**ITEM 5. SECTION 96(2) APPLICATION: UNIT 35-35B/1A COULSON STREET ERSKINEVILLE**

FILE NO: D/2012/1823/A

Draft CSPC Report S96 D-2012-1823-A.docx

The proposal seeks approval for modifications to the Stage 1 consent including changes to building breaks/openings, deletion of 1 level of basement car parking, minor amendment to the Level 6 setback and changes to the ground level to comply with flooding controls.

Figure 15: Revised Stage 1 DA building envelopes

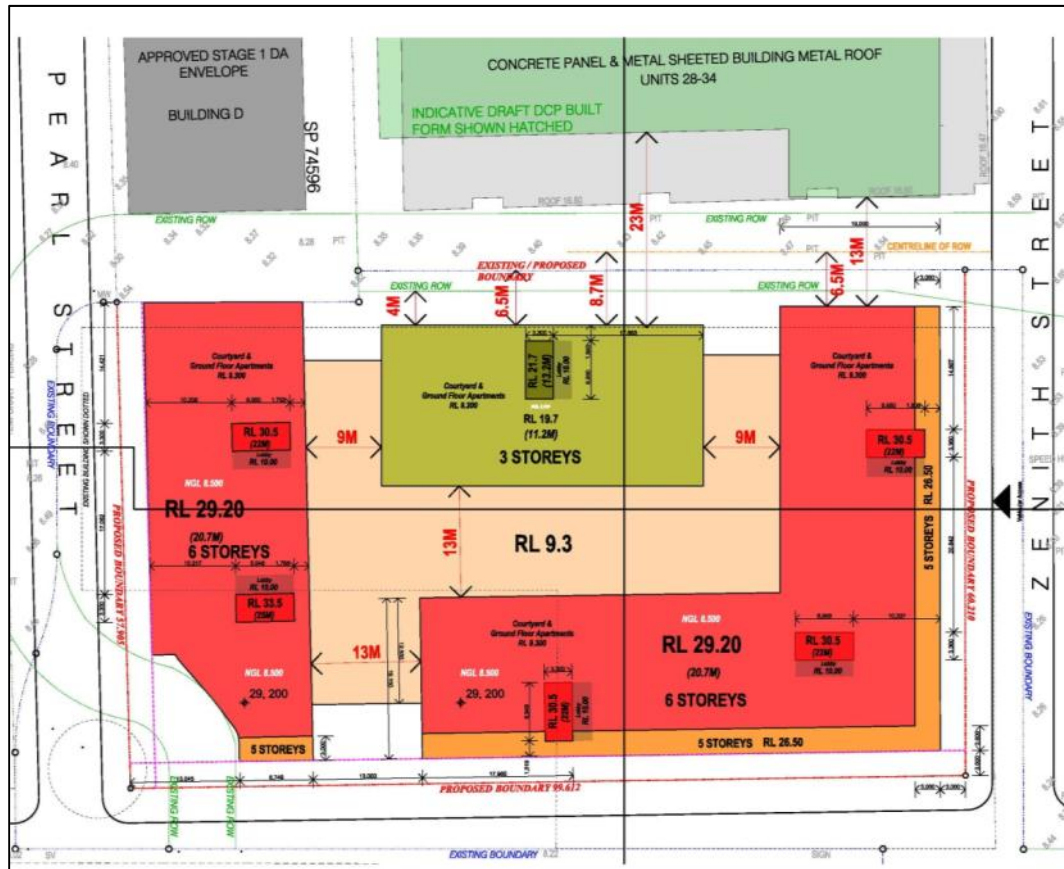
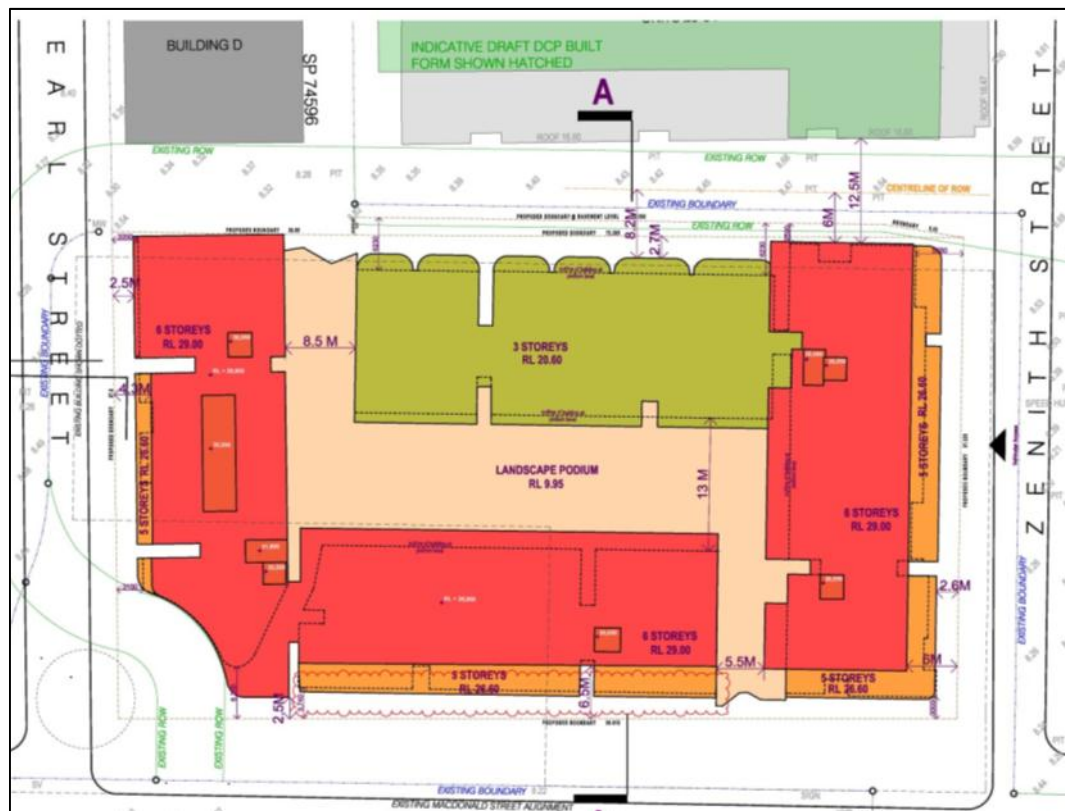
- (b) The modified envelopes provide for appropriate modulation and articulation of facades through the use of deep and wide building slots and sightlines into the central courtyard which also assist in reducing the scale of the proposal.

- (c) The changes to the siting of the proposed buildings still provides for breaks between buildings, albeit in different locations.
  - (d) The modified envelope of the 3 storey northern building fronting the future pedestrian through-link provides an appropriate transition in scale from the adjoining 6 storey eastern building. This building envelope has been amended to include increased articulation and a detailed form that will assist with providing an appropriate sense of scale along the pedestrian link, in lieu of the existing building gap.

- (e) The proposed modifications allow for the retention of the internal landscaped courtyard and landscaped setbacks. The increased envelope of the 3 storey northern building allows for additional area to be provided on the roof of this building for a landscaped common open space area, as detailed in the Stage 2 development application.

Figure 16: Level 6 plan indicating the extent of DCP encroachments

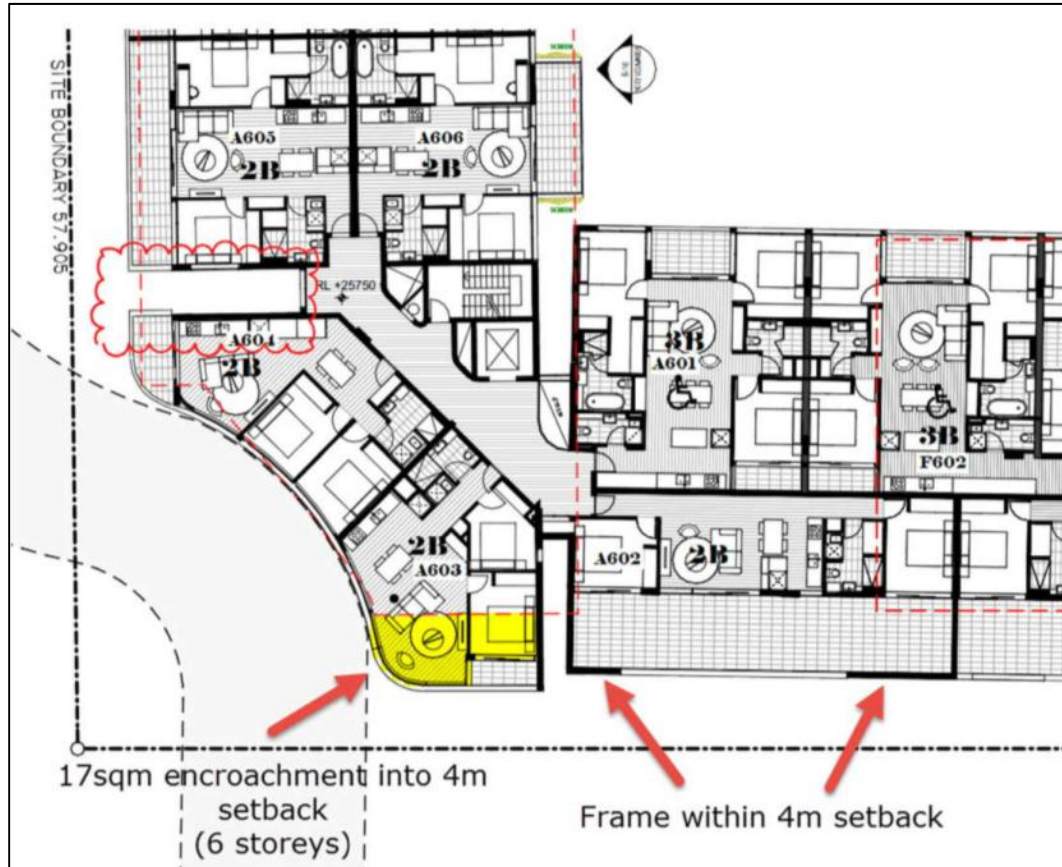
| 5. Specific Areas  |            |   |
|--|------------|---|
| 5.5.2 Urban design principles - transition of building heights                     | Acceptable | The modification is compliant with setbacks, with the exception of the sixth storey, which encroaches into the 4m setback control that applies to that level.<br><br>Refer to Issues section.   |

26. The modifications seek to align the approved stage 1 DA with the Competitive Design Alternatives Process (design competition) winning design prepared by dKO architecture. The design of the winning scheme creates a non-compliance with the setback and height in storey provisions at the upper level of the building facing Macdonald Street.
27. The DCP requires buildings be setback 4m above the street frontage height. In this instance the street frontage height is 5 storeys. Consistent with the setback control, the height in storey control nominates 5 storeys as the height limit immediately fronting Macdonald Street and then 6 storeys from the 4m setback point onwards.

**Figure 18:** Extent of non-compliance with DCP controls

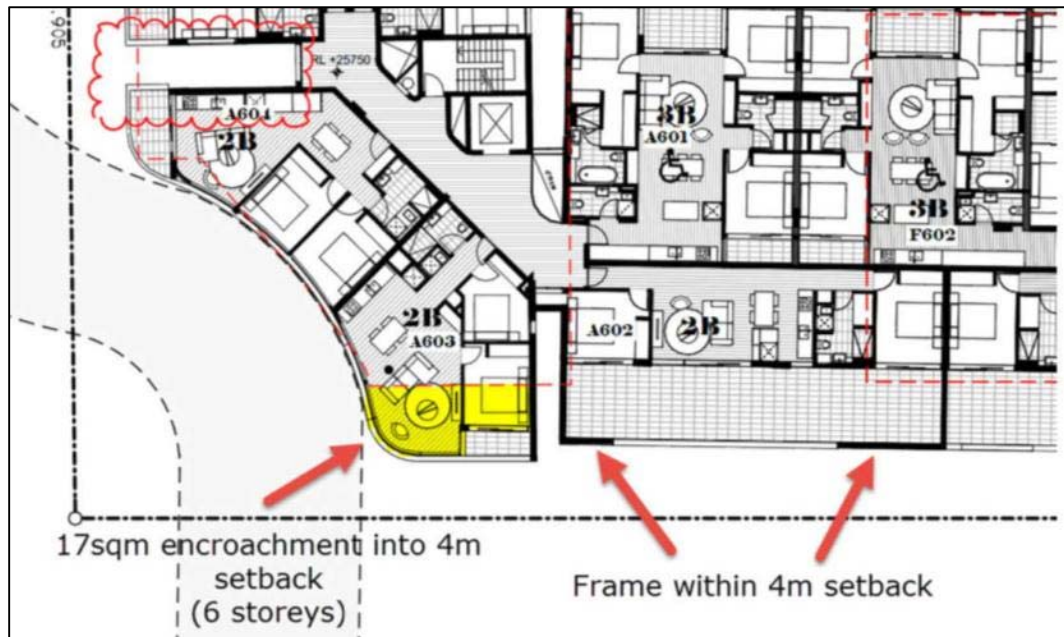
28. The extent of non-compliance with the setback and height in storey controls is illustrated in Figure 17 and Figure 18.

29. The impact of the non-compliance is considered to be minor in this instance. The winning design has sought to respond to the constraints posed by the existing right of carriageway that traverses the south western corner of the site, as well as creating a strong and distinctive corner treatment.
30. Shadow diagrams submitted with the proposal show that the adjoining development to the south will receive in excess of 2 hours of sunlight to living spaces and balconies on the 21 June. The impacts of the non-compliance in terms of overshadowing are minor.
31. It is considered that the architectural integrity of the winning scheme would be adversely affected if it was required to strictly comply with the setback control. The proposed modification to the approved envelope is considered to have merit and is supported.
